SEWAGE DISPOSAL SYSTEM

HOWARD COUNTY HEALTH DEPARTMENT

SUBDIVISION Ridgewood LOT 31 ROAD 13300 Royden Court

REPAIR - PURPOSE --TO RELOCATE PORTIONS OF SEPTIC SYSTEM TO ACCOMMODATE HOUSE ADDITION.

BP 53223

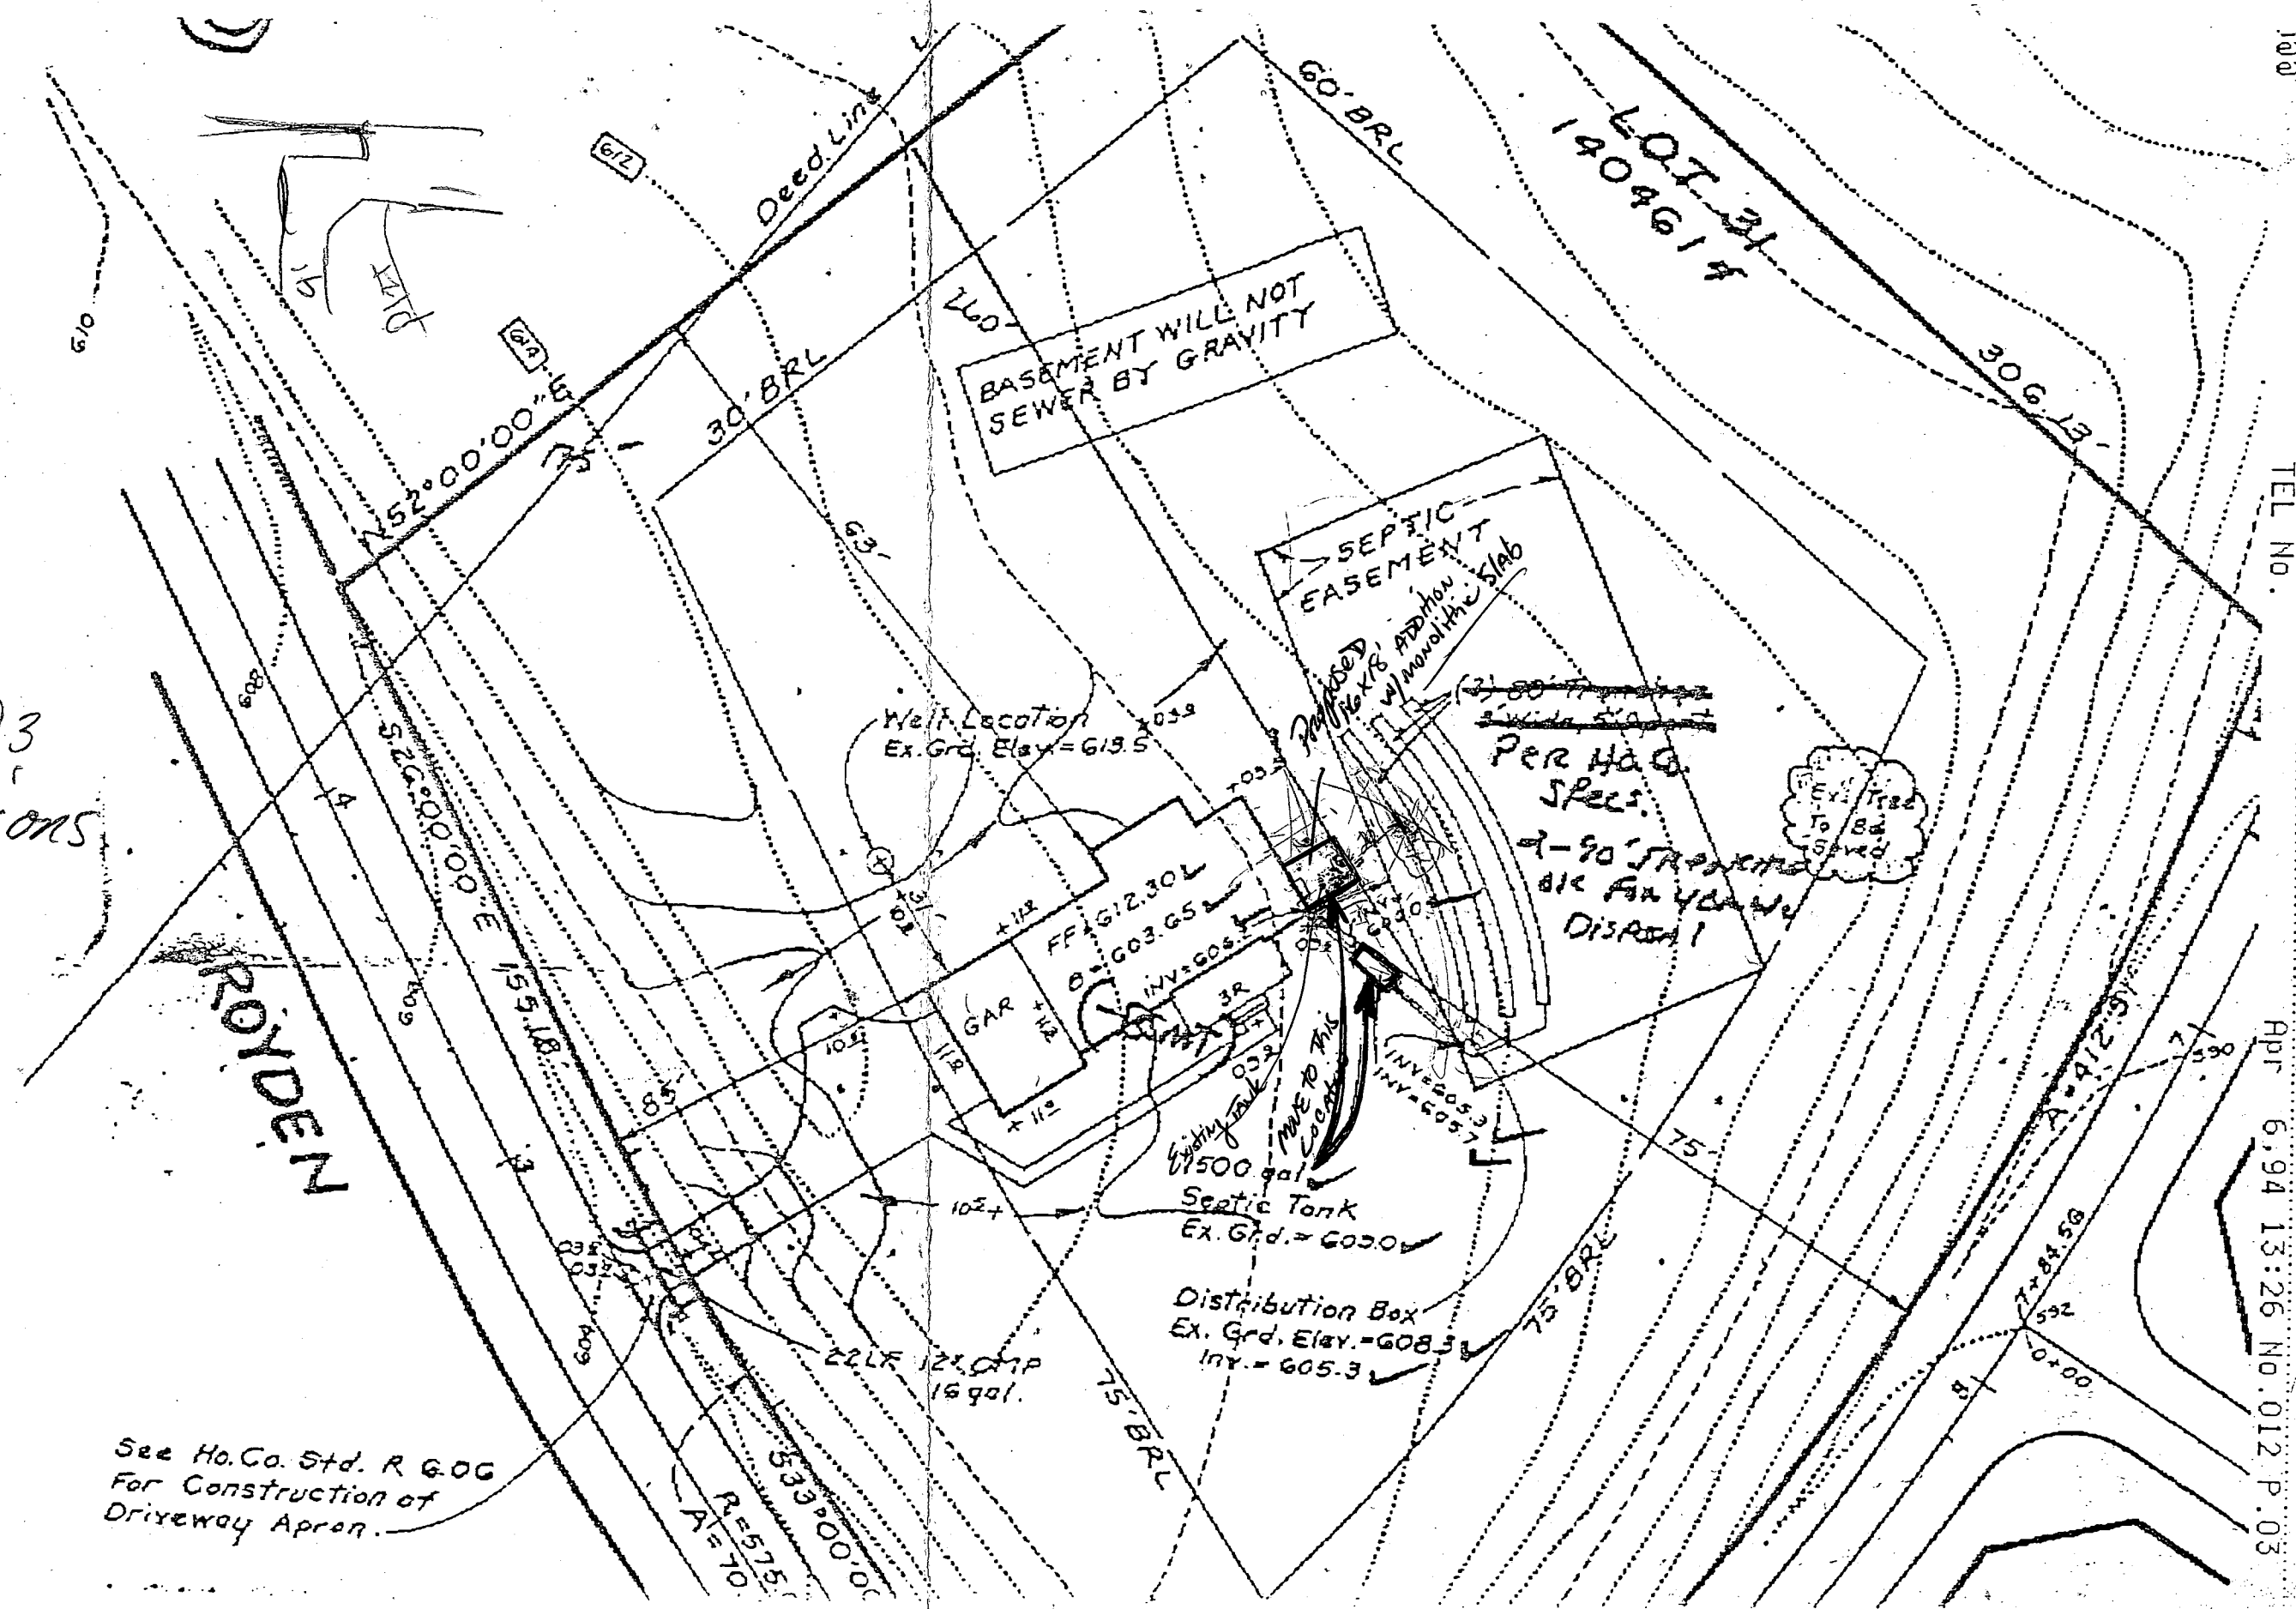
Botanical Decorators hereby agrees
To Remove Existing Holding tank and
move to new location as per plans.
Also, outside edge of addition must
not come within 15' of Drain Field
Pipe, ~~so~~ if so, 1st Drain Field pipe must
be removed, and altered in Drain Field.
Subject To Field Inspection.

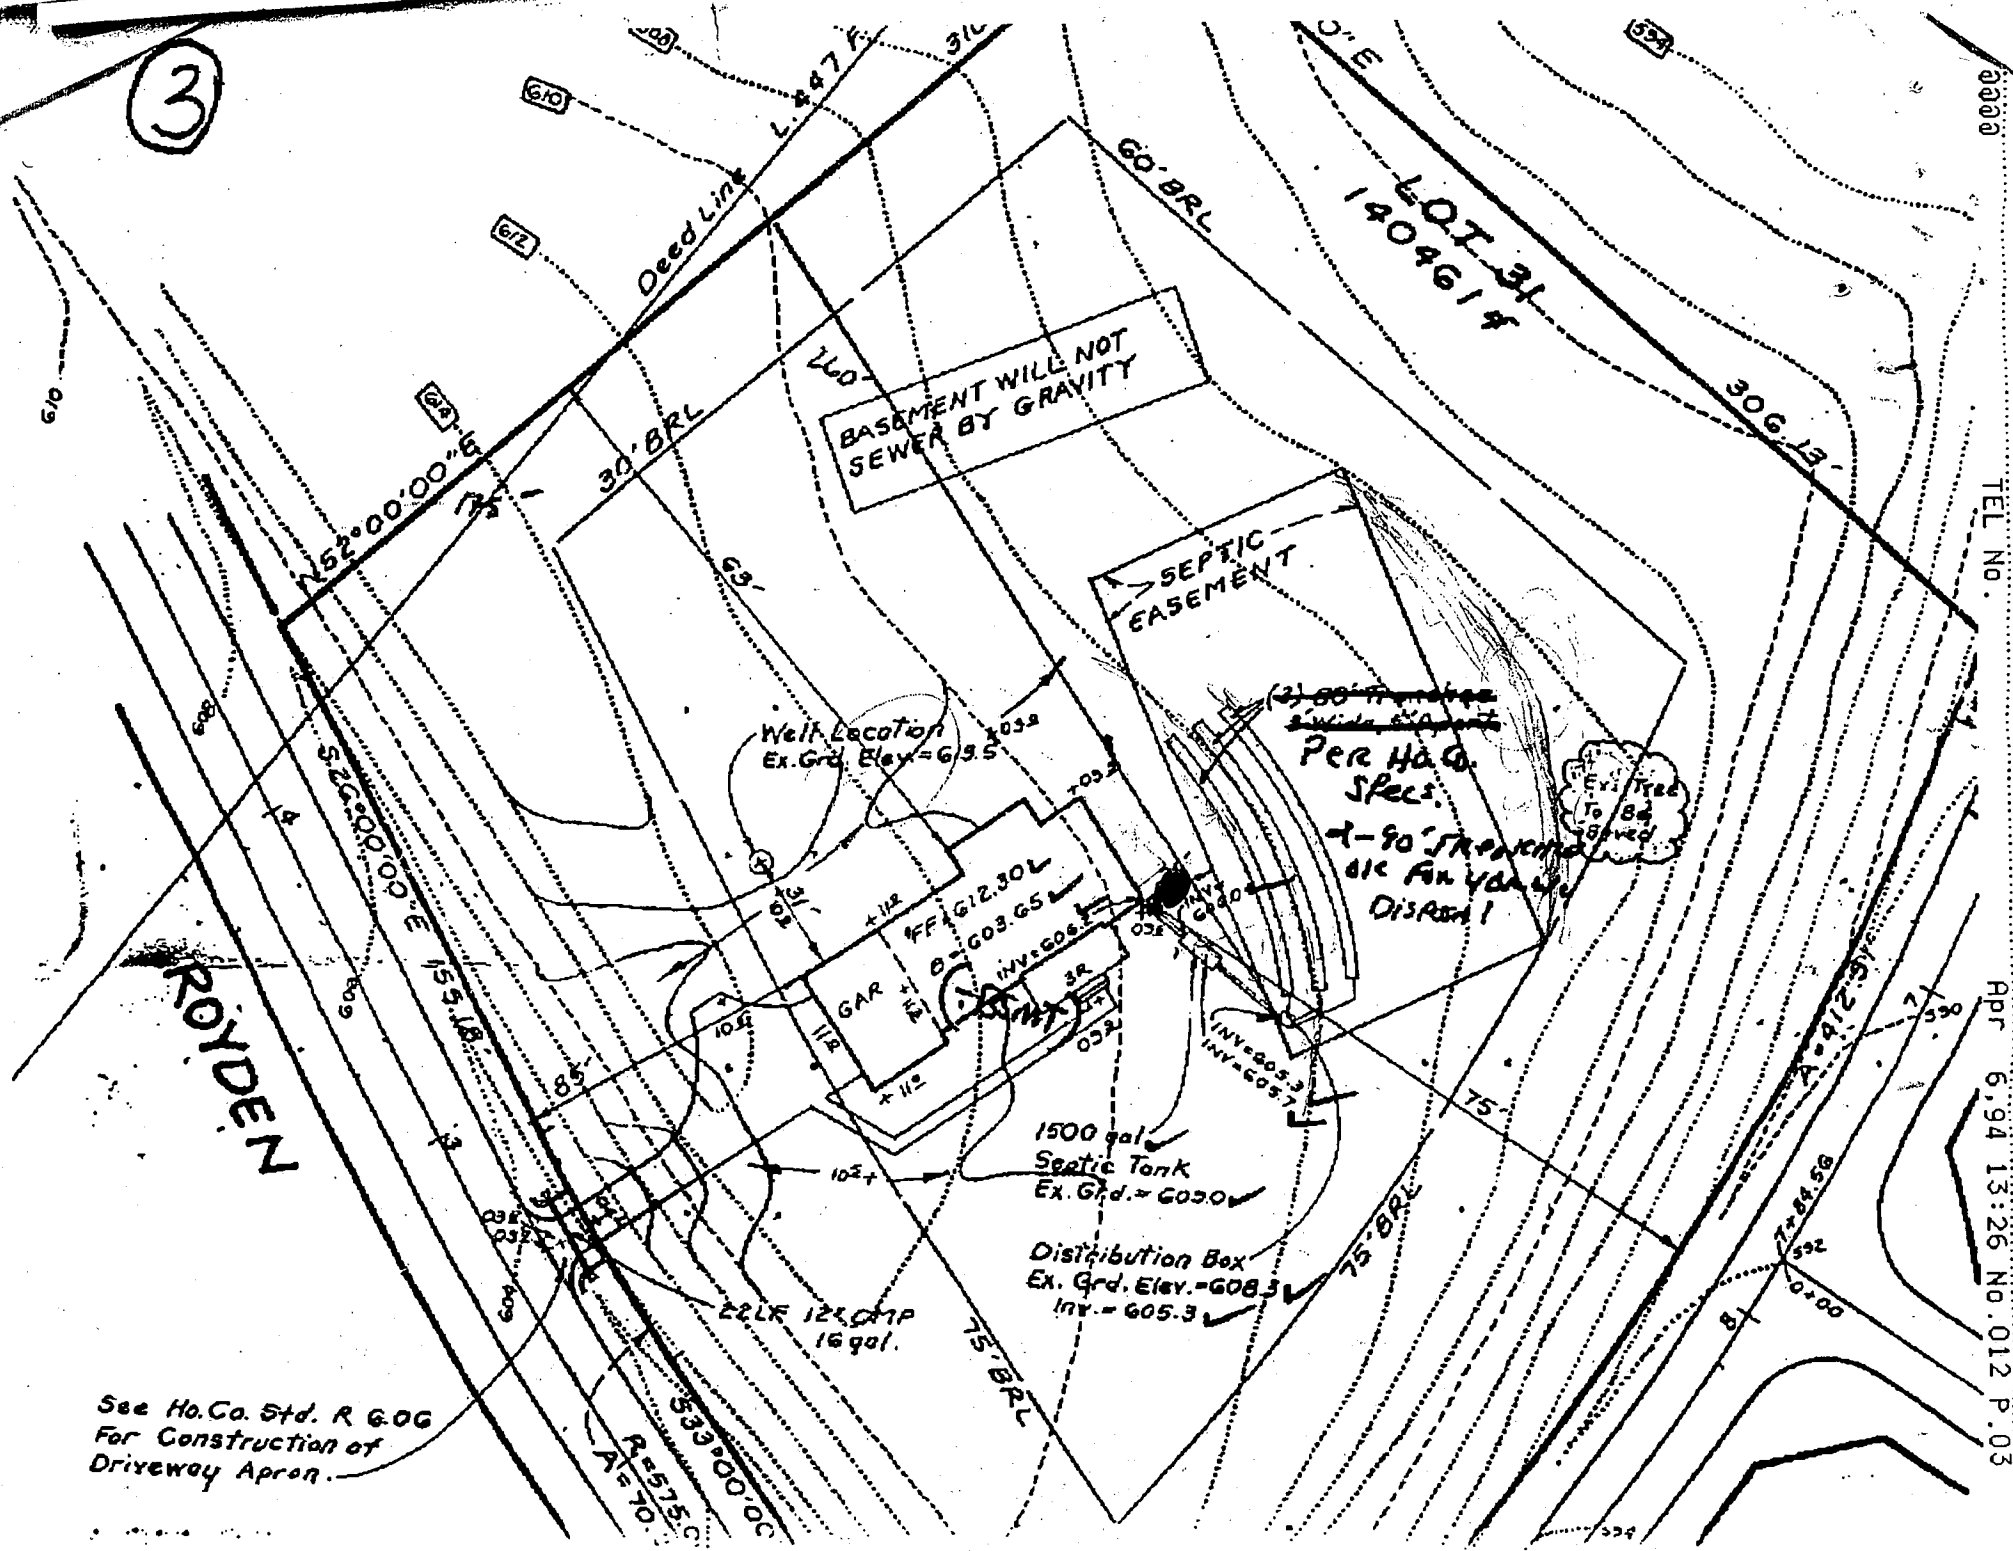
Botanical Decorators hereby agrees
To Remove Existing Holding tank and
move to new location as per plans.
Also, outside EDGE of ADDITION must
not come within 15' of Drain Field
Pipe, ~~so~~ if so, 1st Drain Field pipe must
Be removed, and altered in Drain Field.
Subject To Field Inspection.
